**36 WEST 66TH STREET (A/K/A 50 WEST 66TH STREET)
MANHATTAN BLOCK 1118, LOT 45**

STATEMENT OF FACTS

On behalf of Landmark West! (LW!), we submit this appeal pursuant to Section 666.6(a) of the N.Y.C. Charter and Section 1-06 of the Board of Standards and Appeals (Board) Rules of Practice and Procedure, requesting that the Board reverse the November 19, 2018 decision of the Manhattan Borough Commissioner of the Department of Buildings (DOB) approving the ZD1 Zoning Diagram, filed July 26, 2018, for a new building at 36 West 66th Street (a/k/a 50 West 66th Street) in Manhattan (Building Site). The plans violate Zoning Resolution (ZR) §§ 12-10, 82-34, and 82-36 and N.Y.C. Admin. Code § 28-103.8.

Diagram of George M. Janes

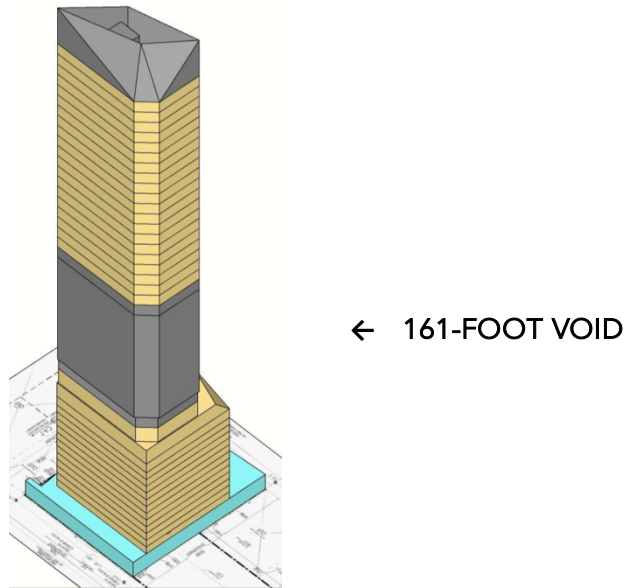
The new plan featured a 161-foot-tall "interbuilding void" beginning on the 18th floor.¹ The Owner claimed the void as mechanical space, but its sole function is to propel the apartments above it to higher price points.²

“substantially compliant” with the mechanical exemption. ZRD2 at 1, 3.³ This ruling ignores the fact that the void has a 161-foot ceiling that takes it out of the definition of “floor space used for mechanical equipment.” It is more than obvious that this floor space will not be “used” for mechanical equipment, or in any event, that any such use is merely incidental to the purpose of raising the apartments above to unprecedented heights.⁴

Diagram of George M. Janes

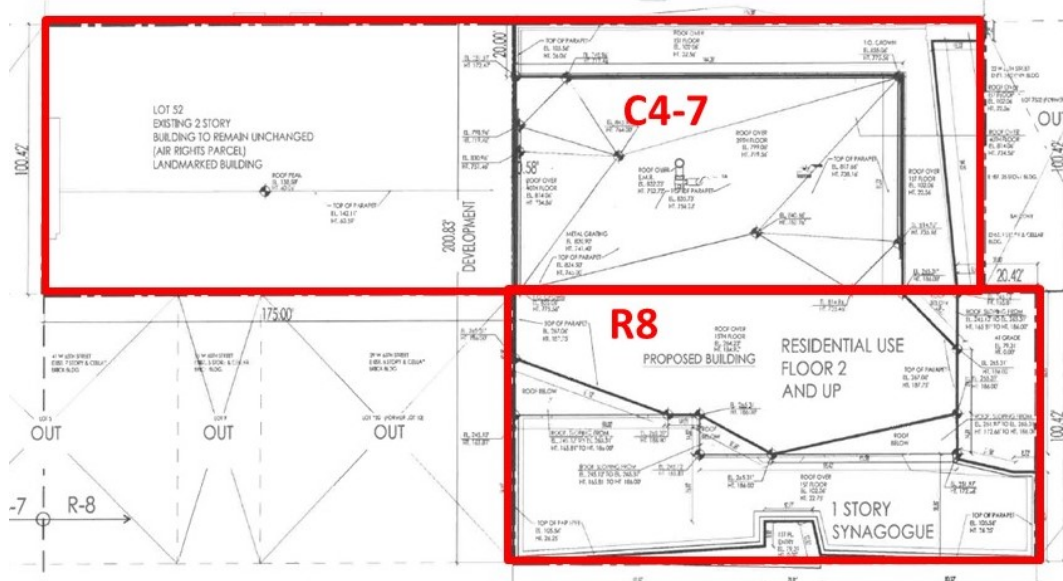
The difficulty in this case arises because the Owner’s zoning lot spans two districts: a portion of it is in a C4-7 District, and another portion is in an R8 District. Towers are allowed in C4-7 Districts, but not in R8s. So the Owner decided to apply the tower coverage rule only to that portion of the zoning lot where towers are allowed. However, it applied the bulk packing rule to the entire zoning lot.

The diagrams below show the whole zoning lot and the portions of it in the C4-7 district.

The result of the Owner’s mix and match approach is a much taller building than would be allowed if both rules were applied to the same lot area. These key components of the tower-on-base regulations can only function as intended when they are applied over the same lot area. The correct approach here is to apply both rules to the tower portion of the lot only. By allowing the relevant bulk to be in completely unrelated buildings on a portion of the lot where no tower can be built, the DOB is essentially saying that the bulk packing rule does not apply to this tower at all. If that rule as well as the tower coverage rule were both calculated based only on the C4-7 portion of the zoning lot where tower rules apply, as they should be, the tower portion of this building would likely be shorter as more floor area would have to be taken out of the area above 150 feet and put into the building base.

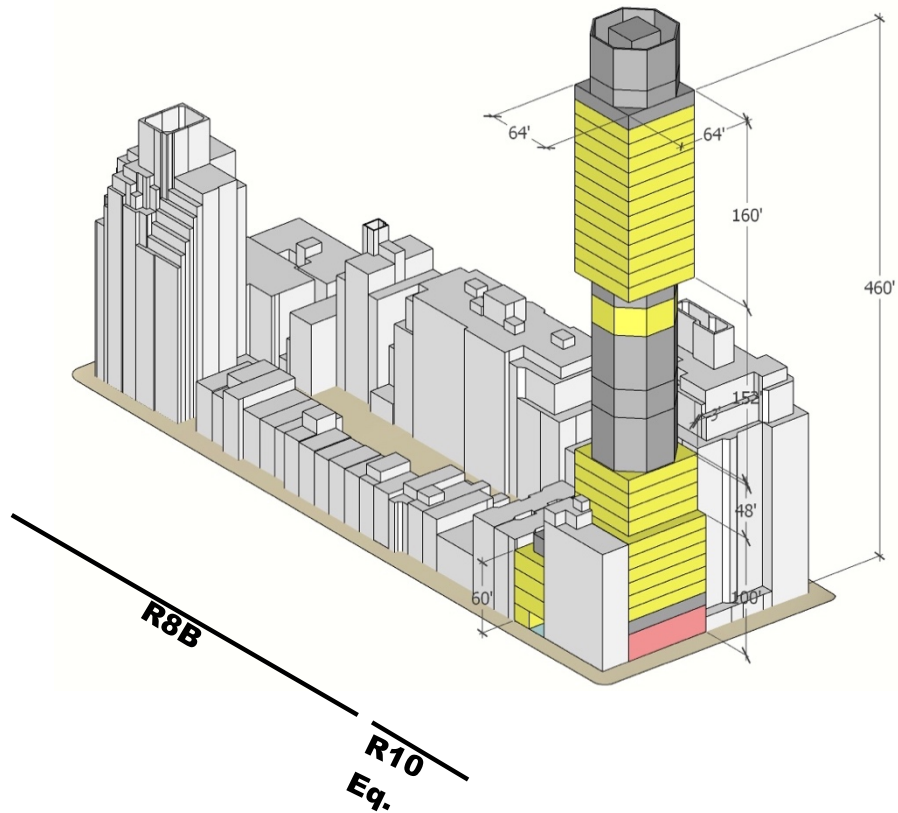
For example, directly to the west and south of the subject zoning lot, there are Lots 9 and 10, which contain existing buildings that are both entirely below 150 feet and are in the R8 District. Using the Owner's logic and interpretation of the SLSD and ZR § 77-02, the applicant could have expanded its zoning lot to include these sites, which would have added approximately 45,000 SF of existing floor area under 150 feet. This zoning lot merger would have required no transfer of floor area, or "air rights," and would not change anything about these existing buildings or materially impair their development potential, other than keeping any future development to less than 150 feet. Their existing floor area would just be used in the tower-on-base calculations, which would have allowed the Owner to construct an even taller building.

Such a paper transaction would have allowed the 45,000 SF floor area in these existing buildings to be counted as below 150 feet in the bulk packing calculations. The net effect of such an action would have been to allow the tower to increase by two stories or 32 feet.⁷

Possible tower-on-base massing if the area for tower coverage is divorced from the area for bulk packing

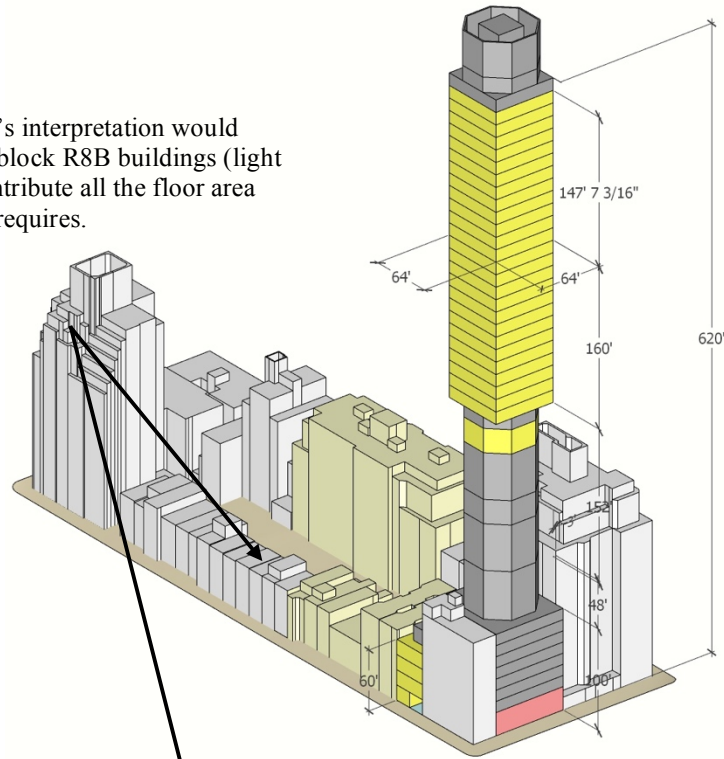
This is another R10 equivalent tower-on-base with a massive void. Here, the R10 equivalent portion of the lot extends only 100 feet in from the wide street the tower faces. If all floor area on the zoning lot under 150 feet can be counted for bulk packing outside the R10 equivalent portion of the lot, and the tower coverage is only counted on the R10 equivalent portion of the zoning lot, then the zoning lot can be expanded to cover much of the block. If that is done, then *all* floor area under 150 feet, with the exception of the ground floor of the new building, will be in buildings to stay on the lot. This zoning lot would require no transfer of development rights and would not impair the future development potential of the existing developments in the height-limited mid-blocks. The following shows how such a building might be massed out:

The applicant's interpretation would allow the midblock R8B buildings (light yellow) to contribute all the floor area bulk packing requires.

The existing buildings added to the zoning lot are shown in light yellow in the midblock. They contribute substantially all the floor area under 150 feet that this new building needs so that the floor area generated on its own lot can be placed at levels higher than 150 feet. In the prior example, there were 13 residential floors over 150 feet. With this interpretation and large zoning lot, 26 residential floors in the main portion of the building are over 150 feet. This example shows expanded mechanical floors acting as a platform to raise the building to 150 feet so that the height can be maintained. It could have just as easily been a single floor designed to be 150 feet floor-to-floor, which while sounding absurdly unrealistic, is actually 11 feet shorter than what the applicant is actually proposing on the 18th floor of its building.
